Re: WBI Energy Transmission, Inc.
Docket Nos. CP20-52-000 and PF19-7-000
North Bakken Expansion Project
Responses to Agency Comments on the Draft Applicant-Prepared Environmental
Assessment

Responses to Agency Comments on the
Draft Applicant-Prepared Environmental Assessment Dated February 4, 2020

100 foot right-of-way typical

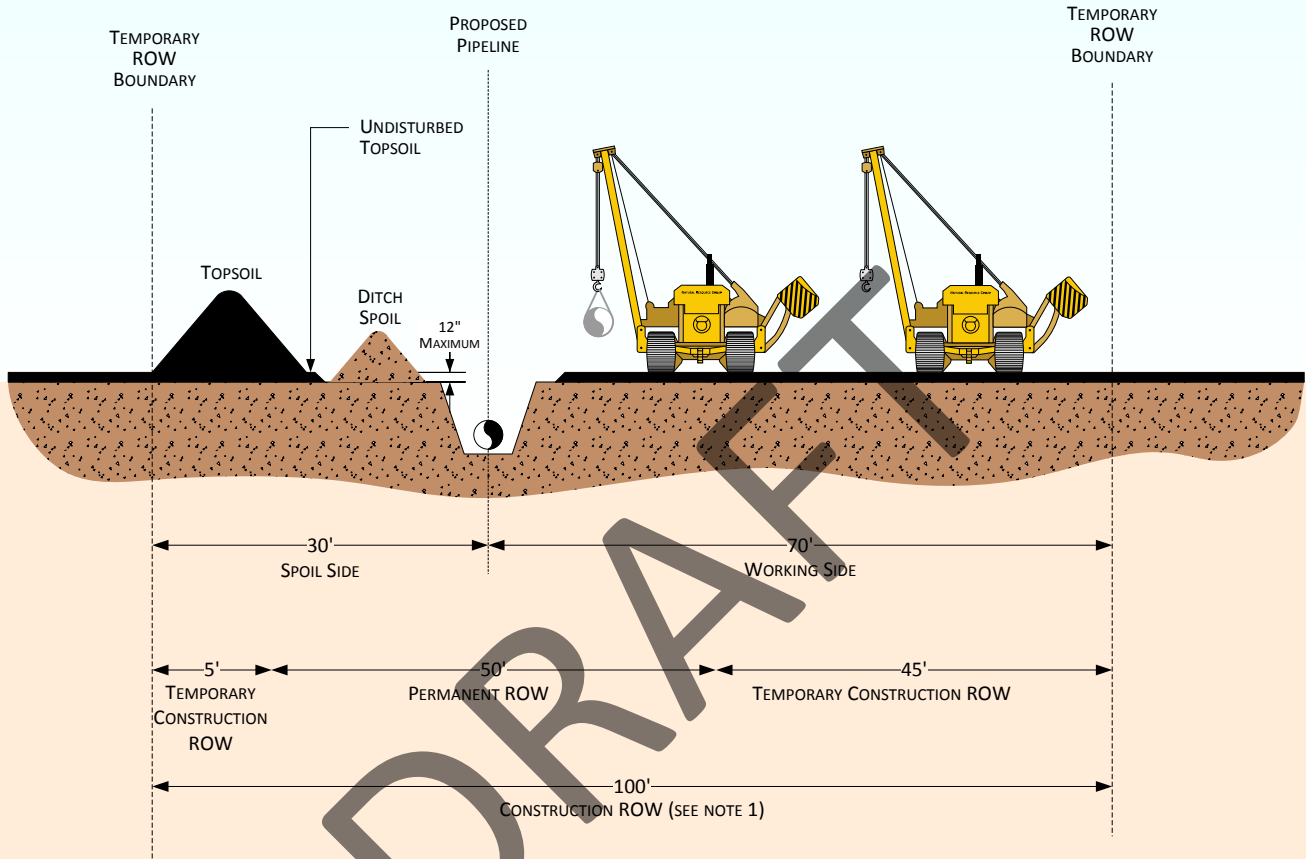
Clarify in section A.8 of the environmental assessment (EA) if WBI Energy Transmission Inc. (WBI Energy) is requesting to deviate from the FERC *Upland Erosion Control, Revegetation, and Maintenance Plan* (FERC Plan) by using a 100-foot-wide right-of-way along the entire length of the pipeline (except in wetland areas), or only in areas with steep terrain. If requesting a 100-foot-wide pipeline corridor for the entire length, provide justification.

For construction of the proposed 12-inch-diameter Line Sections 25 and 30 Loop pipelines and the 20-inch-diameter Tioga Compressor Lateral, WBI Energy will use the standard 75-foot-wide construction right-of-way. Except through wetland areas and across U.S. Forest Service (USFS) land,¹ WBI Energy is requesting a 100-foot-wide construction right-of-way along the entire length of the proposed 24-inch-diameter Tioga-Elkhorn Creek and Elkhorn Creek-Northern Border pipelines. This additional 25 feet of right-of-way width will be necessary to provide sufficient workspace to accommodate increased amounts of topsoil and subsoil materials requiring additional storage space while allowing safe passage of construction equipment and material along the working side of the right-of-way during construction. As outlined in the attached typical construction right-of-way diagrams, to aid in revegetation efforts WBI Energy proposes to segregate topsoil in all non-saturated areas affected by standard pipeline construction and not just those areas required by the FERC Plan, which will require additional workspace for topsoil and subsoil storage.

Additionally, a 100-foot-wide right-of-way will allow implementation of proper safety precautions during construction. These safety measures may include but are not limited to:

- After trench excavation, work between the pipe and the trench will be prohibited.
- During lowering-in operations, workers will be positioned between the equipment and the pipe to monitor, inspect, and repair coating as needed or to adjust temporary pipe supports.
- To minimize the potential for trench collapse, construction equipment will be offset from the edge of the trench at a minimum distance equal to that of the depth of the trench.
- The 100-foot right-of-way ensures that there will be travel land around construction equipment for first responders in the event of an incident.

HDD Intersect Method Construction Typical

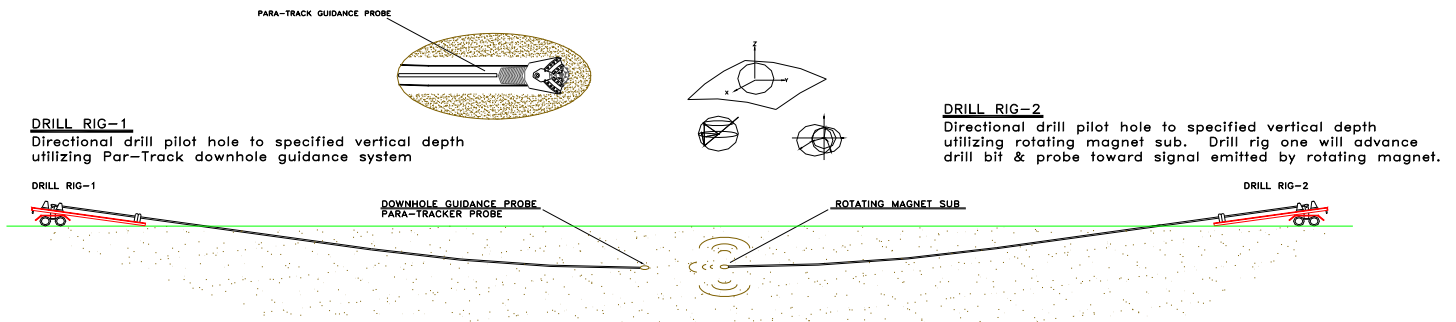
Provide a description of the horizontal directional drill (HDD) interconnect method in section A.8 [now section A.7] of the EA, as detailed in Resource Report 1, as well as an associated construction typical drawing illustrating this method.

The following description of the HDD intersect method has been added to section A.7.2 of the EA.

WBI Energy proposes to use the HDD intersect method to construct its pipeline across Lake Sakakawea (and a natural pond). The HDD intersect method involves using two drill rigs, one on each side of the HDD, and drilling two pilot holes towards each other until they intersect at a predetermined point. Unless unforeseen events occur, such as inadvertent releases of drilling fluid, use of the HDD method typically avoids impacts on water quality by precluding disturbance of the waterbody bed and banks.

WBI Energy's HDD contractor proposes to use either the Para-Track System or the Gyroscope System to complete the HDD intersect crossing (see the HDD intersect typical construction drawing). Both systems involve using a directional jetting bottom-hole assembly or a mud motor with a bit and bottom-hole assembly to advance a 12.25-inch-diameter drill bit from each of the HDD entry sites (one at the drill rig entry side and one at the pipe entry side). Because HDD intersect procedures do not need to occur at exactly the halfway point along the drill path, drilling can occur concurrently from both sides or start at different times. Although the HDD intersect point is predetermined, conditions encountered during drilling the pilot holes may dictate the exact location of the final intersect point. The two drill crews would maintain constant communication as the HDD pilot holes progress.
